**State Historic Preservation Office/Office of Parks, Recreation and Historic Preservation**  
**(NYSHPO/OPRHP) Correspondence Summary**

*Revised January 2022*

**Reference:** South Ripley Solar Project  
Revised Facility Layout  
NYSHPO Project Review # 20PR03687

Figure 2. Proposed Facility Layout

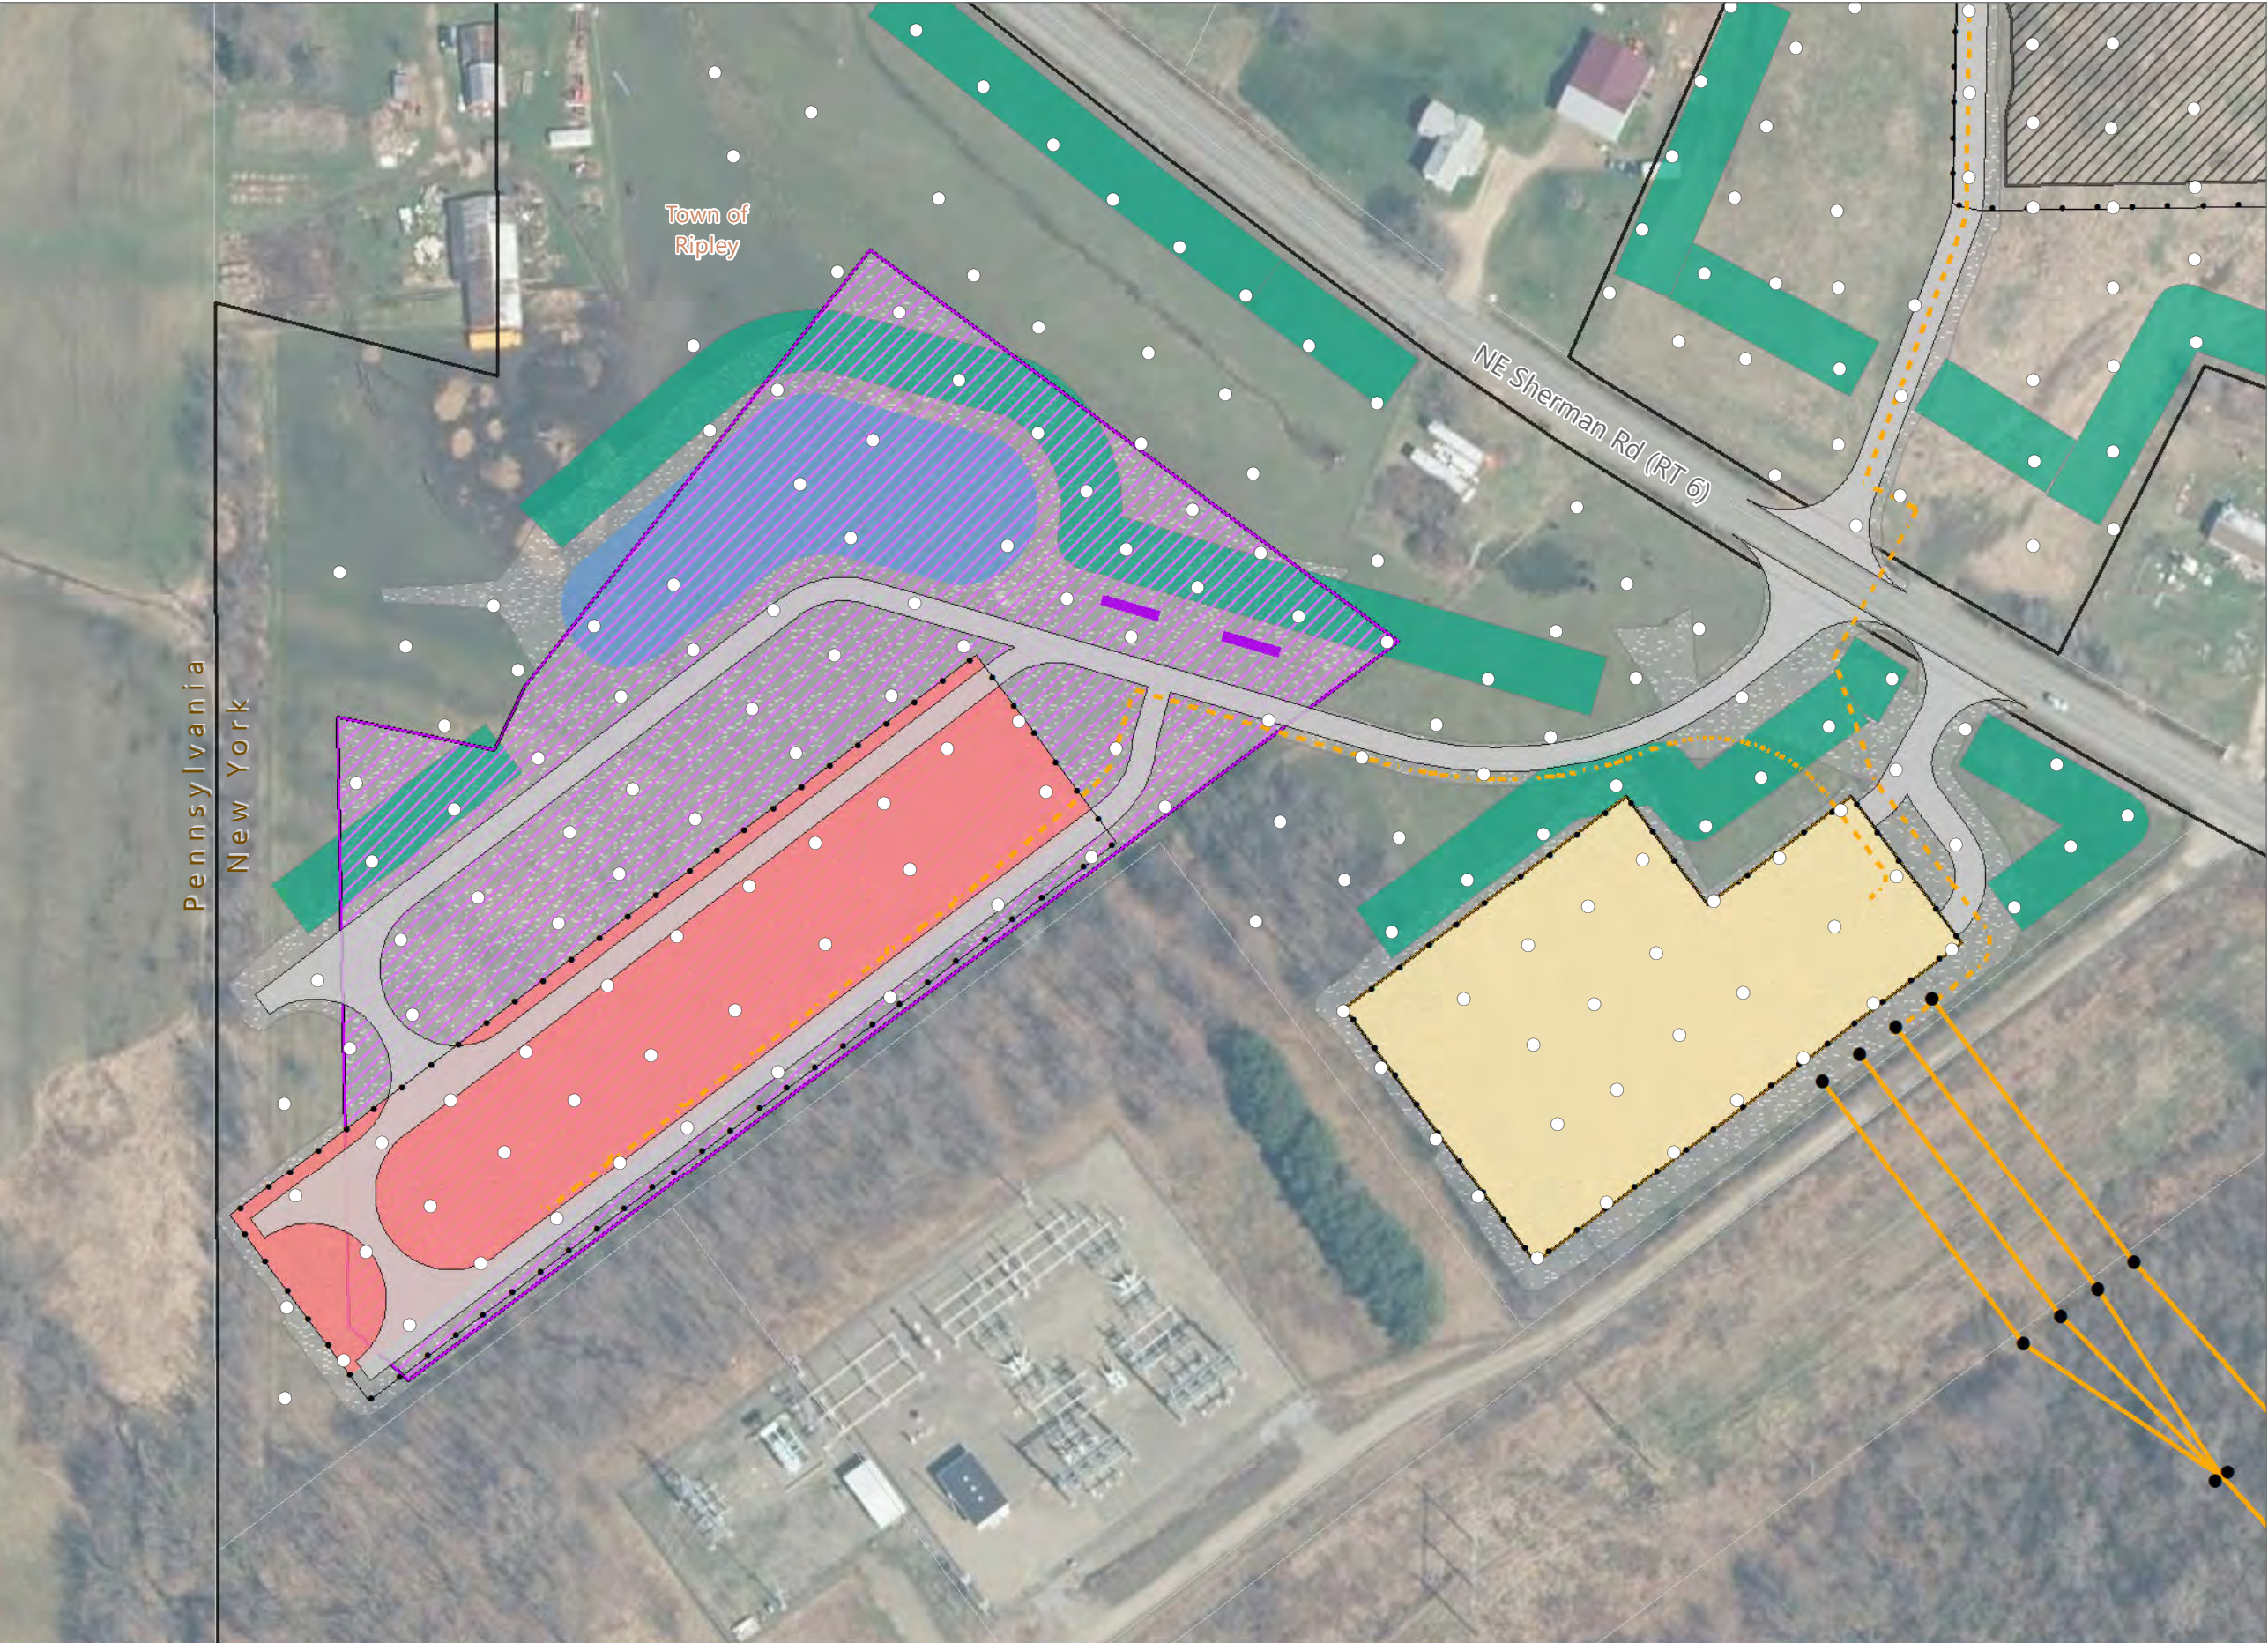
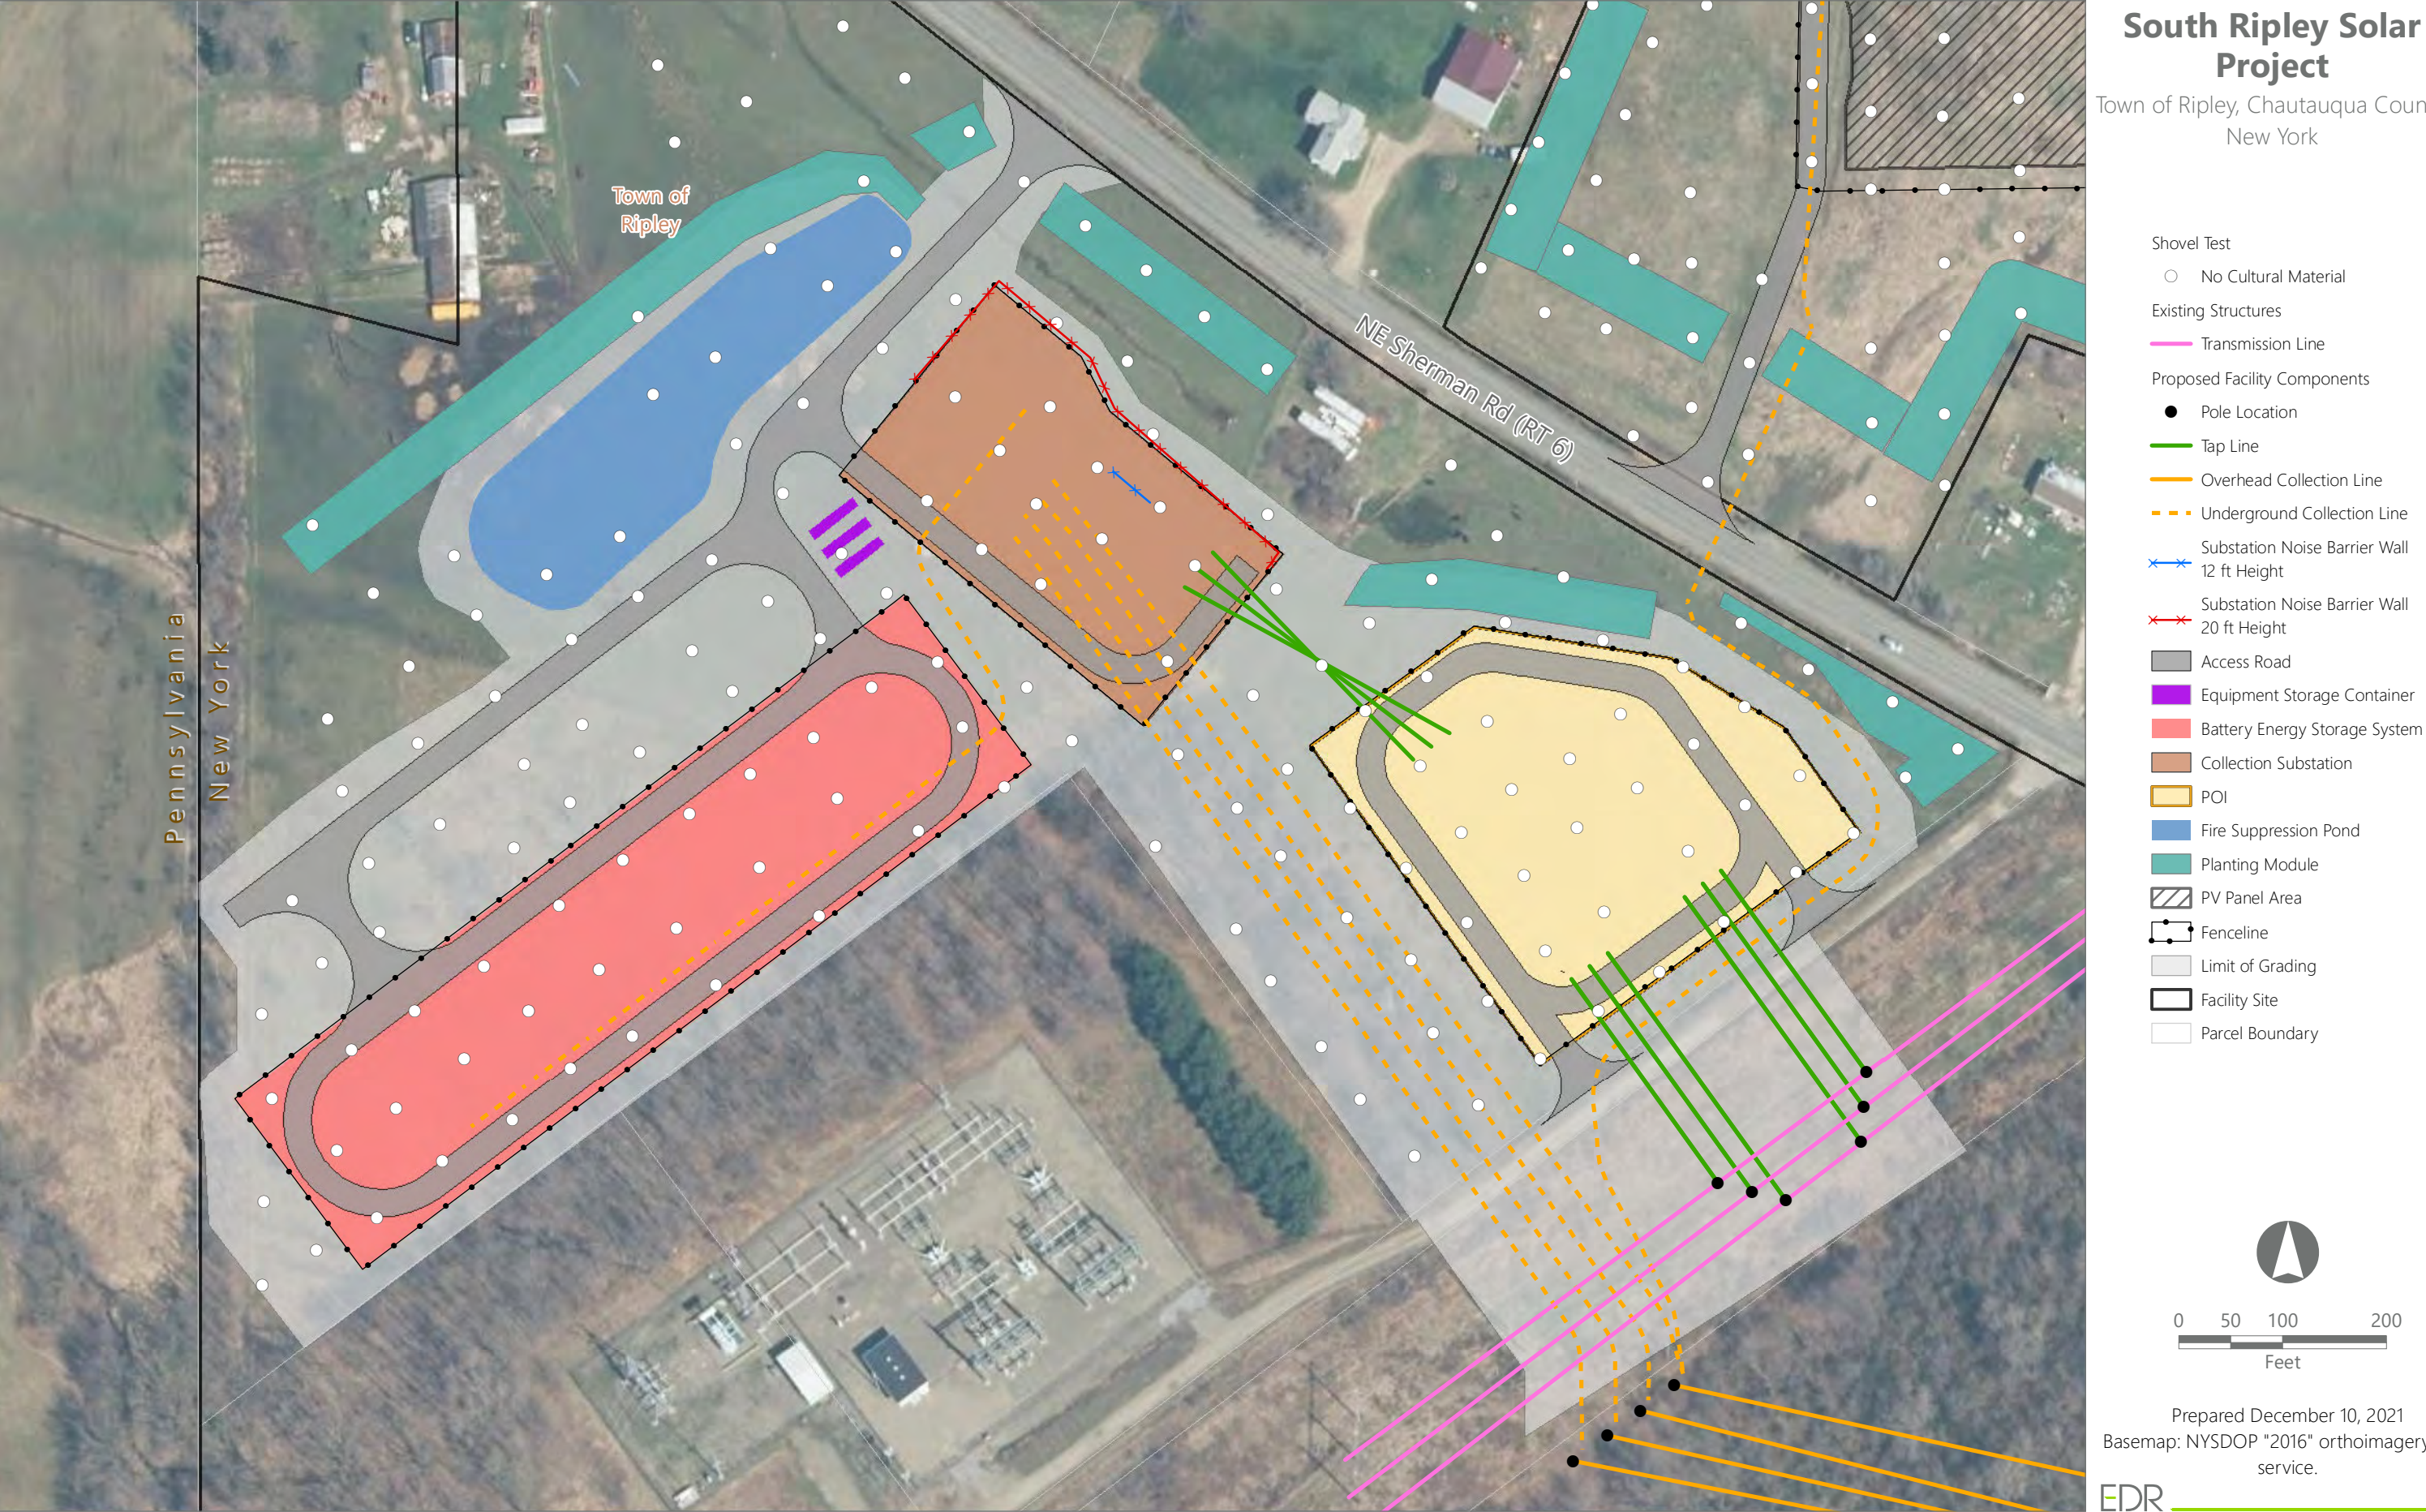
The collection substation will be moved from the originally proposed location in the previous design to north of the Battery Energy Storage System (BESS) and it will tie into a new 3-breaker ring POI rather than the existing National Grid substation. It will contain the same equipment as before, but potentially in a different configuration or arrangement within the substation fence. This will require adjustments to fence line and access roads to both the collection substation and the BESS. The noise barrier walls will be located on the northeast and northwest sides of the collection substation and will be approximately 20 feet in height. The fire suppression pond will be located to the northwest of the collection substation. In addition, planting modules will be installed along the northeast and northwest sides of the interconnection facilities. The planting modules will be consistent with Module 4 of the planting modules described in the *Visual Impacts Minimization and Mitigation Plan* (EDR, 2021c), previously submitted to NYSHPO on August 13, 2021.

The locations of the components included as part of the proposed interconnection facilities are indicated on Figure 2.
